Subject: Revised Final Site Specific Work Plan Amendment 2, Eastern Bypass OE Removal Area, Task Order 0010, Ordnance and Explosive Response at Fort McClellan, Alabama, Contract Number DACA87-99-D-0010

The following Amendment 2 to the EBP Site Specific Work Plan Revision 3 Amendment 1 is for the clearance of construction debris areas within the EBP right of way (ROW). This amendment covers only those paragraphs that have additions or are new and need to be added to the original document.

**Figure 1.3  
Construction Debris  
Areas**

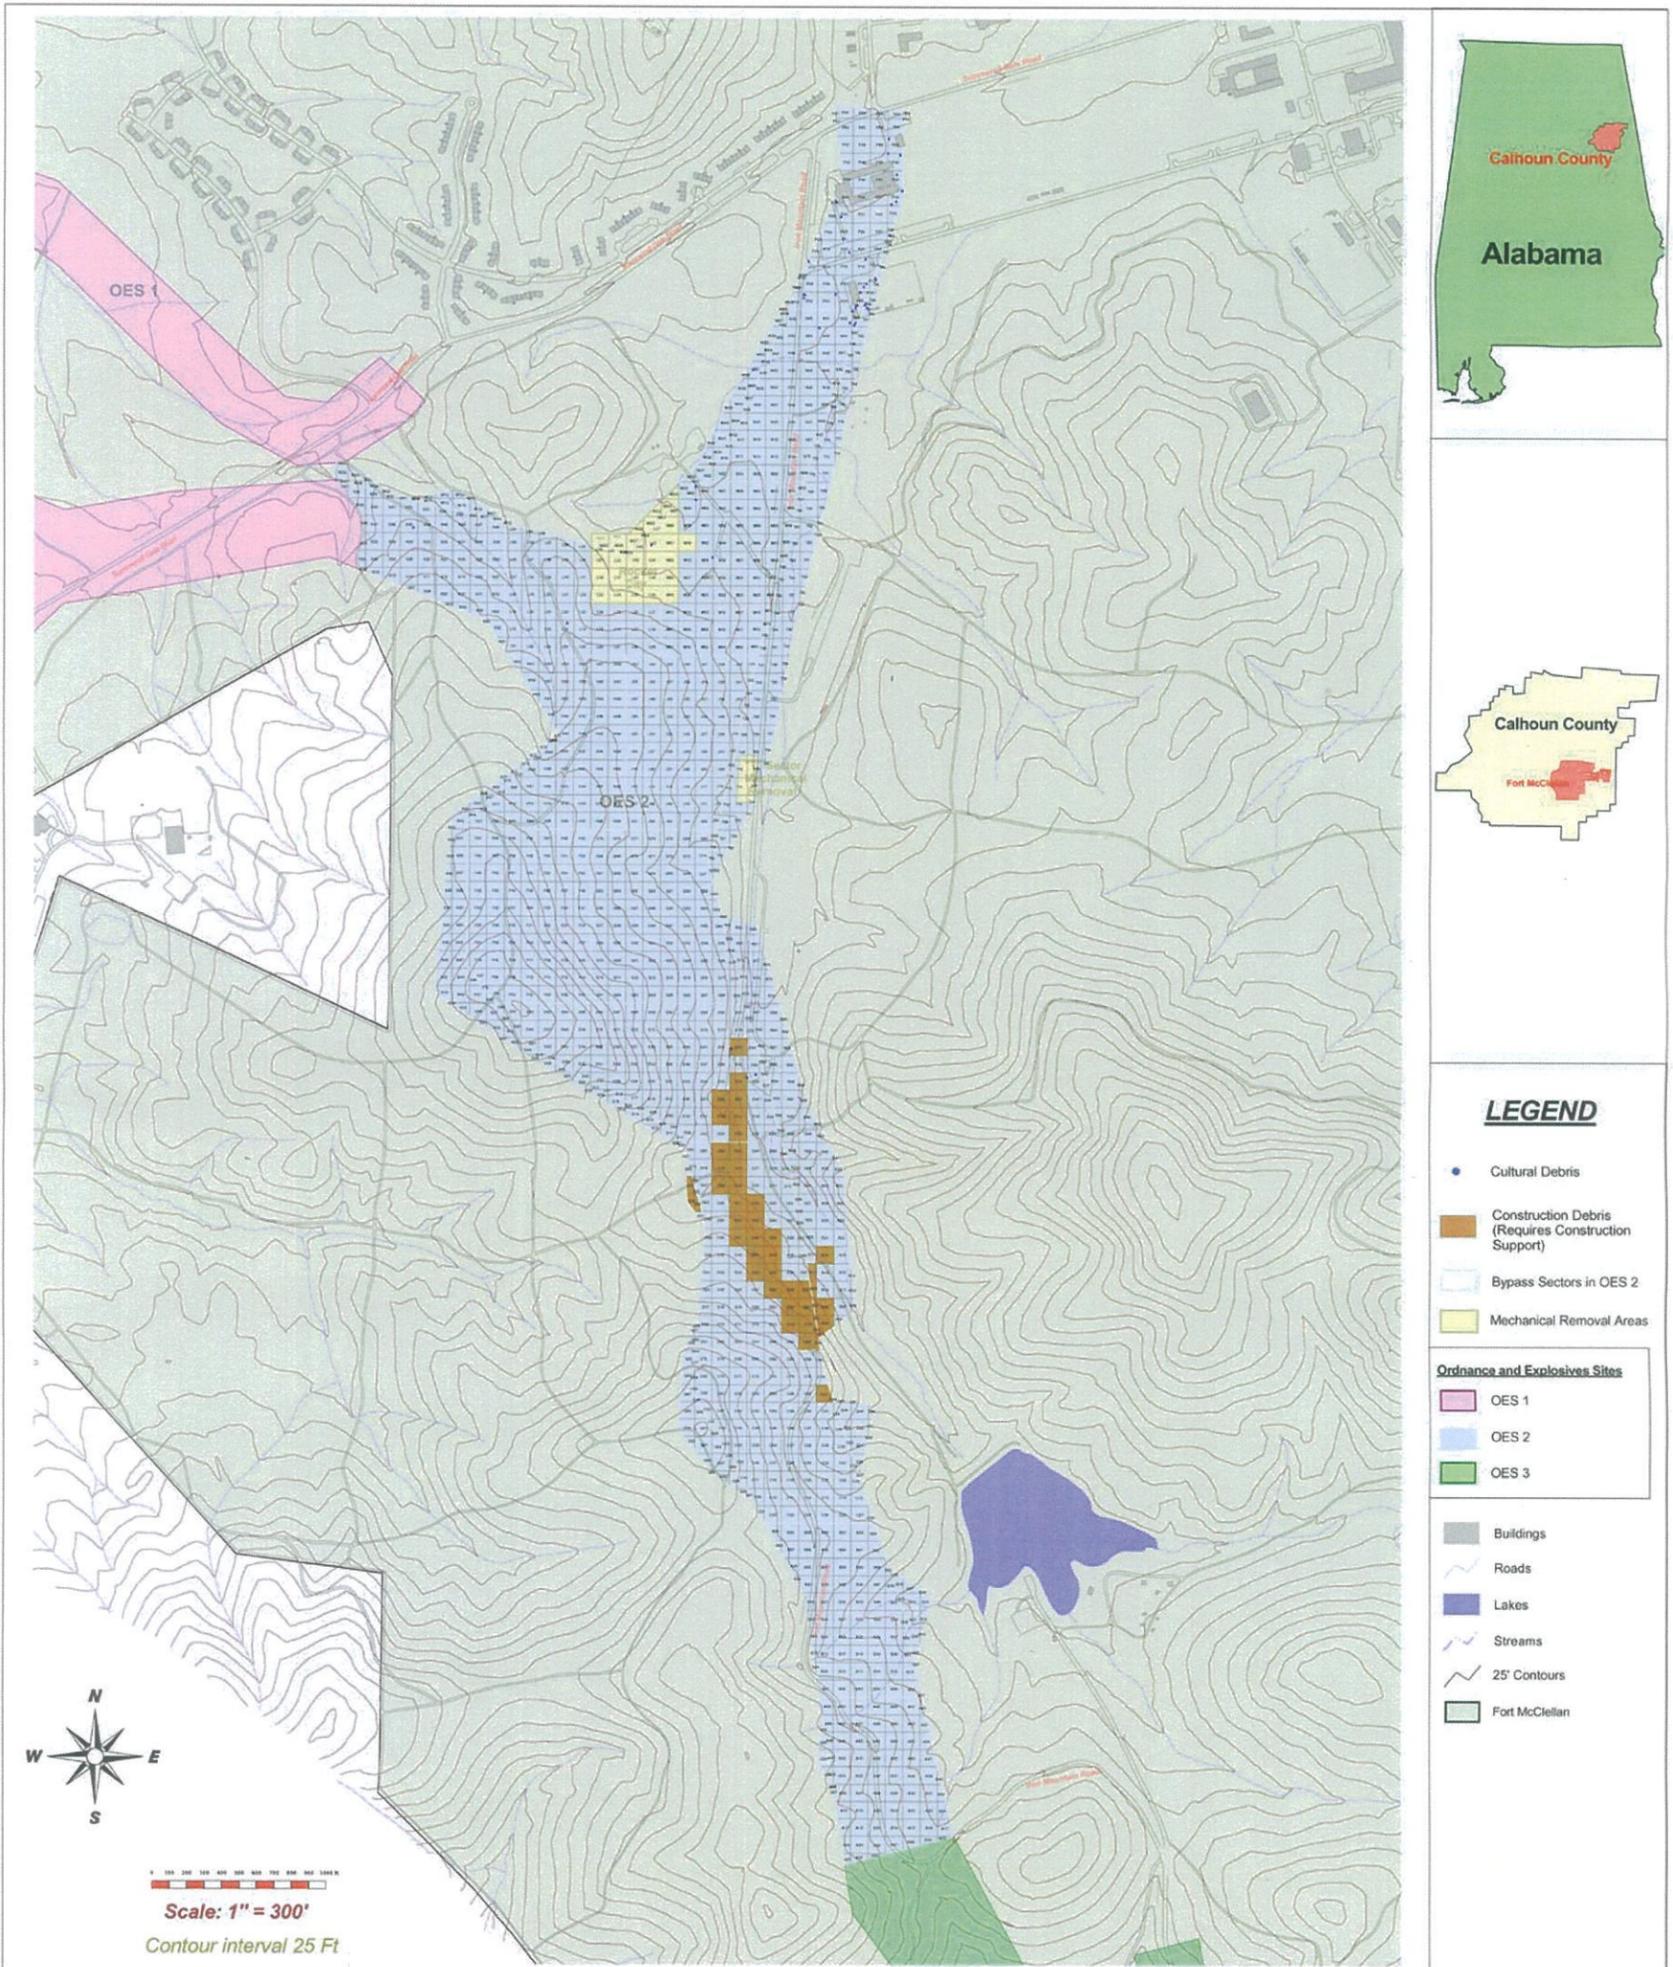
the fill, then using approved UXO procedures to clear the soil underneath. The UXO procedures will include a mix of digital geophysics and standard mag and dig procedures as described in the SSWP for the EBP. Figure 1.3 shows the grids that were not cleared during the EBP removal because of the presence of construction debris. In discussion held with ALDOT, the Army, TtFWI and ADEM it was determined that any of these grids that were not going to be covered by at least 4 feet of fill during the construction of the EBP would require a clearance before ALDOT could perform construction activities in these areas. Based on this discussion, ALDOT provided the technical drawings and the Army compiled that information over the existing grid layout to determine which grids required a removal under this task order. Figure 2.6 shows the grids that were not cleared, overlaid with the area that will not be filled to over 4 feet, thus showing the grids or portions of grids that will be cleared as part of this task order. A 10 foot buffer was added around all of the areas to be cleared during this task and is shown on Figure 2.6 also. In addition to the area being cleared due to the addition of less than four feet of fill, ALDOT identified several areas that require clearance as well. The first of these areas is culvert 1 located at station 315+20.88. Culvert 1 spans across several grids and will be cleared to 20 feet wide across the grids. The second area is a spring box located at station 314+07. The spring box will require a trench to be dug to 15 feet wide into the construction debris grids until the source of the spring is found, Figure 2.6 shows the approximate location of the expected spring box trench. The third area is culvert 2 located at station 310+00 and will only require a short trench, approximately 10 feet long and 20 feet wide where it enters the clearance area. These areas are shown on Figure 2.6. The following paragraphs explain the details of the Construction Debris Removal.
